14506  
10 March 2017

**RESPONSE TO SUBMISSIONS  
NORTH EAST PLOT (SSD 6626 MOD 1)**

Figure 1 – Existing foundation (circled in red) compared to location of Building NE3

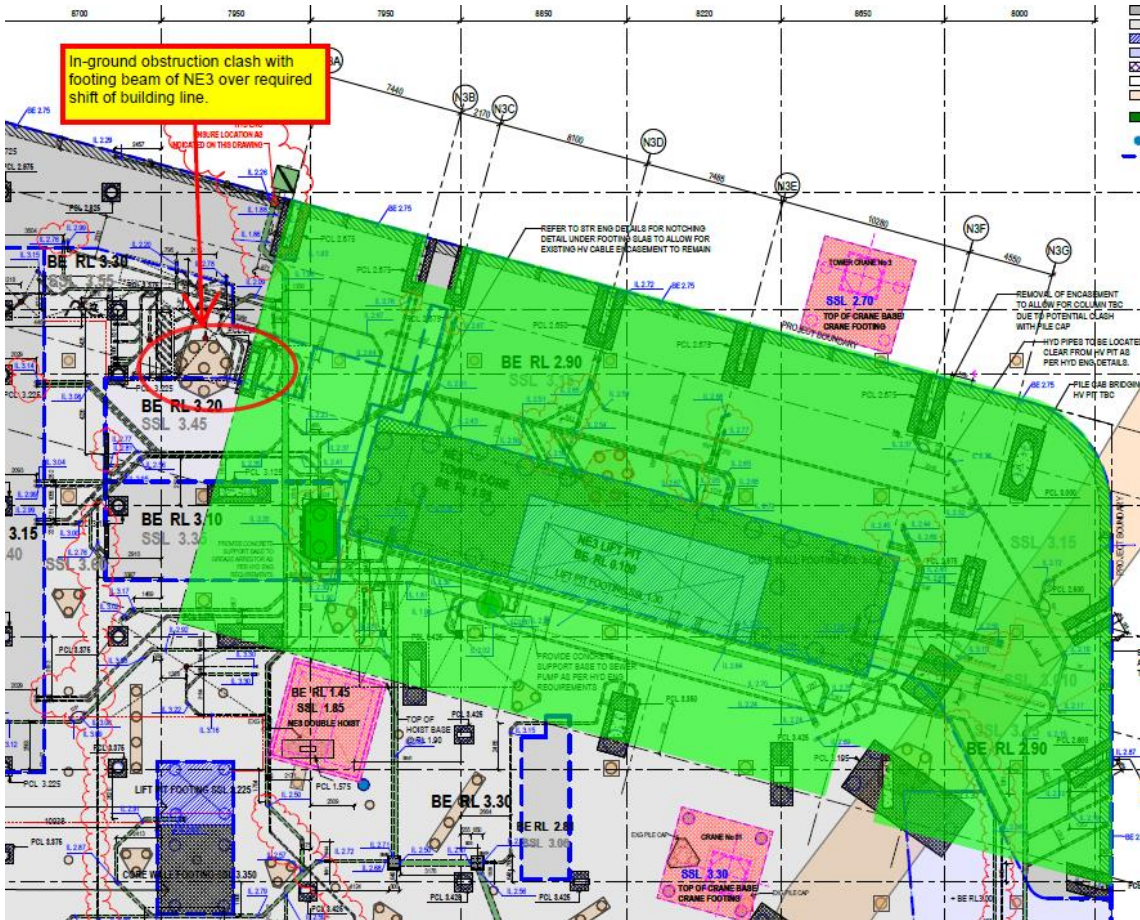
The Department has also requested further justification on the following items:

- relocation of the western façade of Building NE3 in the context of residential amenity; and
- relocated fire tank in relation to its size and access arrangements, having regard to relevant standards.

It is clarified that the western façade of Building NE3 has shifted 330mm to the east. The Department has requested further justification of this amendment. It is clarified that this amendment has been driven by a number of matters, including general design development and importantly as a response to in-ground site conditions which were not precisely defined at the time the original development consent was granted.

An existing foundation associated with the SEC was identified below the location of the previous western wall of Building NE3. In order to avoid significant in-ground works to remove this foundation, the wall has been shifted 330mm to the east. The relationship of Building NE3 and the foundation is illustrated in Figure 1 below.

In light of the in-ground conditions, the shift of the wall 330mm has allowed for an outcome consistent with the overarching strategy of Darling Square. The flow on effect of this change therefore needs to be considered, particularly on residential apartments in the western portion of Building NE3.
